Access Compliance Report Public Rights-of-Way (Curb Ramps)

Intersection ID: 31304 Main Street: WESTBEND DR **Cross Street: ALEXANDER POINTE DR** Location: SW ADA ID: 33A358B2A23D Ramp Type: PerpDiag Initial Pass/Fail: Fail **Overall Compliance: No** Severity Score: 58.75

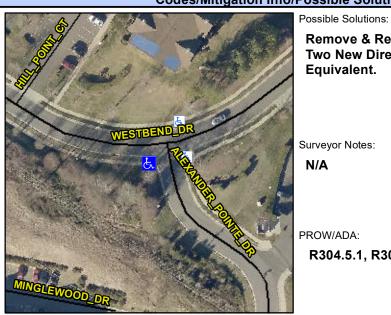
R304.5.1, R304.2.2, R304.5.3

Comp	liance Description	Data	Comp	liance Description	Data
N/A	Ramp Length (in)	48.0	No	Ramp Slope (%)	14.8
No	Ramp Width (in)	39.0	No	Ramp XSlope (%)	9.1
N/A	Flare Type LT	N/A	N/A	Flare Type RT	N/A
N/A	Flare Slope LT (%)	N/A	N/A	Flare Slope RT (%)	N/A
N/A	Flare Traversable LT?	N/A	N/A	Flare Traversable RT?	N/A
N/A	Landing Length (in)	N/A	N/A	DWS Provided?	N/A
N/A	Landing Width (in)	N/A	N/A	DWS Contrast?	N/A
N/A	Landing Slope (%)	N/A	N/A	DWS Length (in)	N/A
N/A	Landing X Slope (%)	N/A	N/A	DWS Full Width?	N/A
N/A	Landing Curb? (Y/N)	N/A	N/A	DWS Offset (in)	N/A
N/A	Shared Landing?	N/A			
N/A	Gutter Ponding?	N/A	N/A	Gutter Slope (%)	N/A
N/A	Gutter Lip Ht (in)	N/A	N/A	Gutter X Slope (%)	N/A
N/A	Painted X Walk1?	No	N/A	Painted X Walk2?	No
	X Walk 1 Direction	To E		X Walk 2 Direction	To N
N/A	X Walk 1 Width (in)	N/A	N/A	X Walk 2 Width (in)	N/A
	X Walk 1 Slope (%)	4.6		X Walk 2 Slope (%)	0.5
	X Walk 1 X Slope (%)	4.2		X Walk 2 X Slope (%)	5.5

Remove & Replace Curb Ramp With Two New Directional Ramps or Equivalent.
